Technical Service Bulletin

No. B501-07v2
22 April 2005

Subject/Concern/Concern:	Possible Causes of Water Ingress into the Vehicle
---------------------------------	---

Models/Models:	XJ Range	VIN-range: G00442 Onwards
-----------------------	----------	---------------------------

E62679

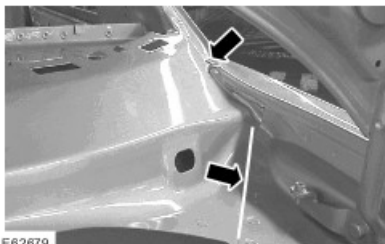
- 11 . **Issue:** Water ingress into the spare wheel well and the luggage compartment carpet is wet towards the front of the luggage compartment. **Possible Cause:** Hole in sealer between the rear fender and bottom corner of backlight panel, or forward channel seam leaking.

E62680

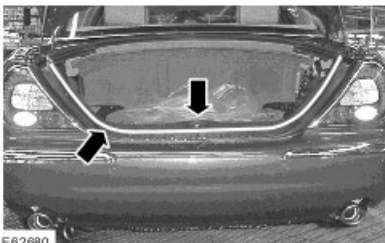
- 22 . **Issue:** Water ingress into the spare wheel well and the luggage compartment carpet is wet. **Possible cause:** Water tracking underneath the luggage compartment aperture seal.

E62681

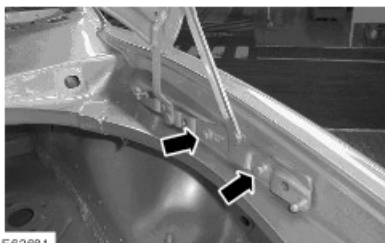
- 33 . **Issue:** The luggage compartment carpet is wet at one or both sides. **Possible cause:** Water ingress through luggage compartment lid hinge securing bolts.

E62682

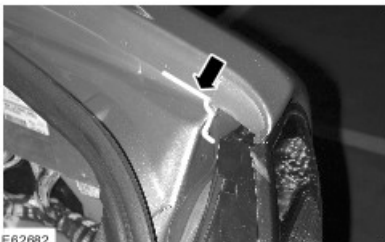
- 44 . **Issue:** The luggage compartment carpet is wet towards the rear of the luggage compartment. **Possible cause:** Rear fender seam leaking.

E62683

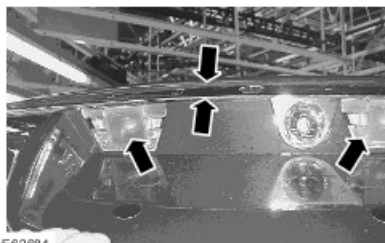
- 55 . **Issue:** Water ingress onto the spare wheel well. **NOTENOTE:** Water leak mainly from vertical part of the seam.

Possible cause: Luggage compartment floor seams leaking.

E62685

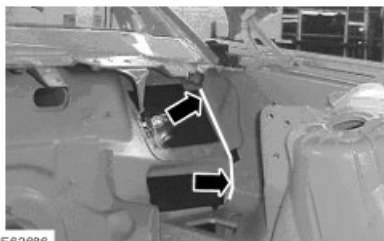
- 77 . **Issue:** Water ingress into the driver footwell. **NOTENOTE:** Apply a suitable wet sealant to the area shown.

Possible cause: Water can track between the 'body in white' panels where the lower steering column exits the bulkhead.

E62687

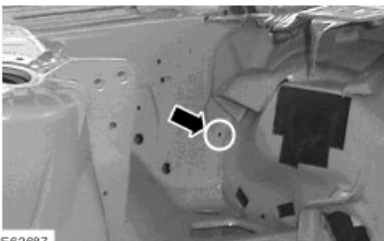
- 99 . **Issue:** Water ingress into the front passenger footwell. **NOTENOTE:** On driver side this hole is used to mount the plenum drain tube. On passenger side a blanking patch is installed.

Possible cause: Patch over hole can leak water.

E62688

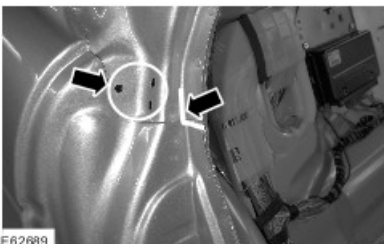
- 1010 **Issue:** Water ingress into the front footwell. **Possible cause:** Water ingress from harness grommet under front wheel arch.

E62689

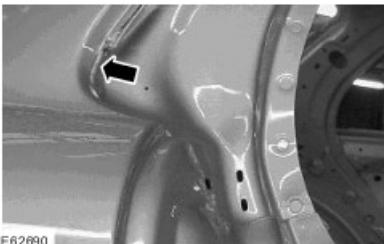
- 1111 **Issue:** Sill carpet wet at rear. **NOTENOTE:** Remove rubber finisher and apply a suitable wet sealant (to the areas shown) to block the water path.

Possible cause: Water tracks under the rubber finisher along the C-pillar/door shut joint and/or behind the rubber finisher fixings, then down along draft welt.

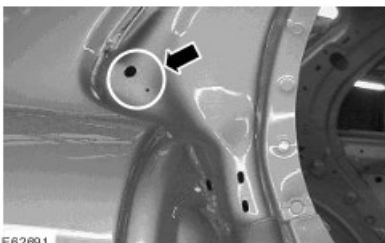
- 1313 **Issue:** Water ingress into the cabin. **NOTENOTE:** Pull away finisher for access, remove two fixings securing the drain channel clip and apply a suitable wet sealant around the fixing holes (areas shown) to block the water path.

Possible cause: Water ingress through the drain channel finisher fixings.

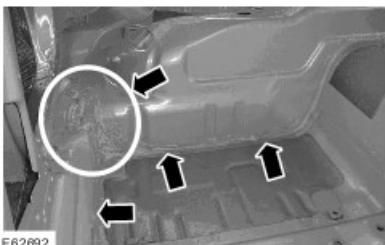
1414 **Issue:** Water ingress into the rear of the cabin. **Possible cause:** Water ingress through the seams by the rear seat.

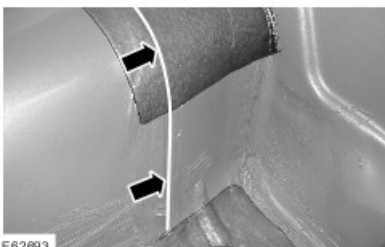
1515 **Issue:** Long Wheel Base Vehicles Only - Water ingress into the left-hand and right-hand rear footwells.
NOTENOTE: Illustration, right-hand shown left-hand similar.

Possible cause: Water ingress through the long wheel base extension seem, left-hand and right-hand side.
